MPCP+ GATE processing

Duane Remein

100G-EPON

Split the current SD into two parts

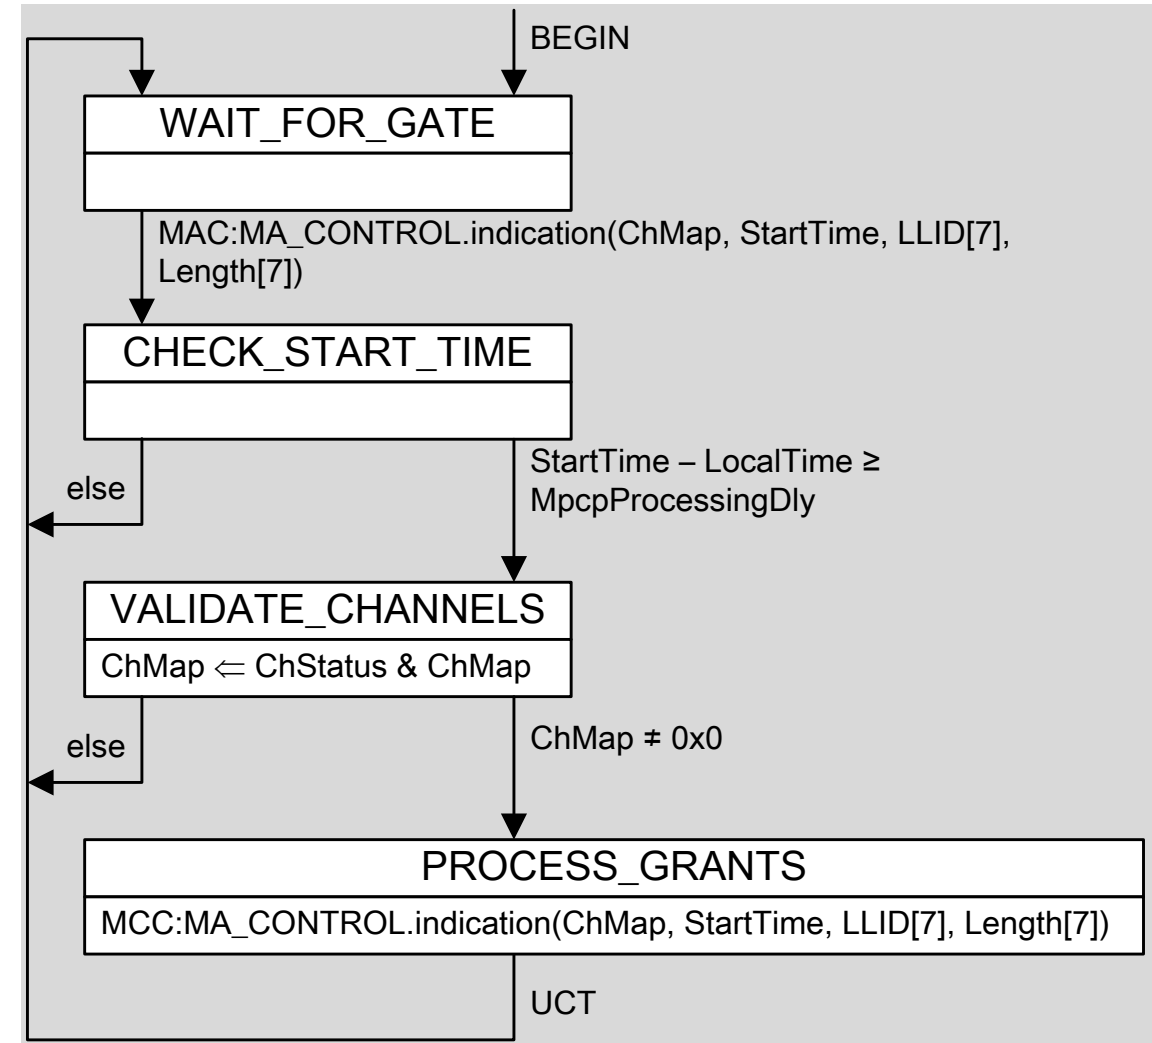
- ❑ MAC Control should have the ability to look at multiple GATE messages when making scheduling (Envelope) decisions
- ❑ Not possible with current SD
 - GATEs are passed to upper layers one at a time and processed completely before another GATE can be presented to the scheduler

- Receives GATE MPCPDUs and passes them to the MAC Control Client (higher layer) via the MA_CONTROL.indication() primitive

- Receives Envelope Descriptors from MAC Control Client via the MA_CONTROL.request() primitive and queues them by channel and start time

Split the ONU GATE Reception Process state diagram into two SDs, GATE Reception Process and Envelope Commitment Process as illustrated in remain_3ca_2_0717.pdf slides 5 through 9.

GATE Reception Process

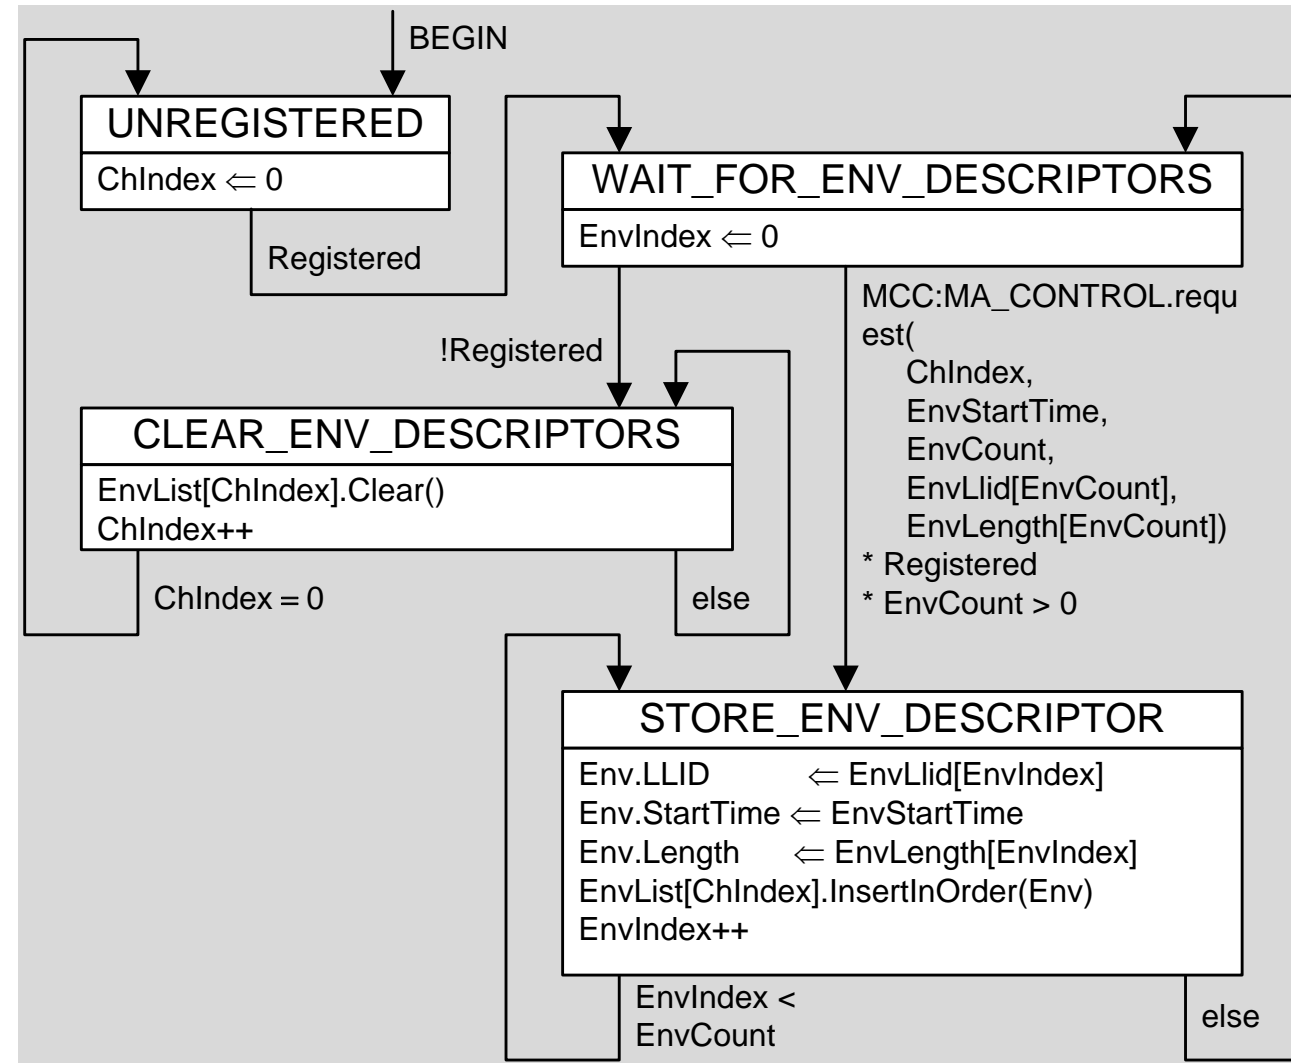
- ❑ Verifies GATE is valid
 - Sufficient processing time
 - Includes at least one enabled channel
- ❑ Passes validated GATE parameters to MAC Control layer
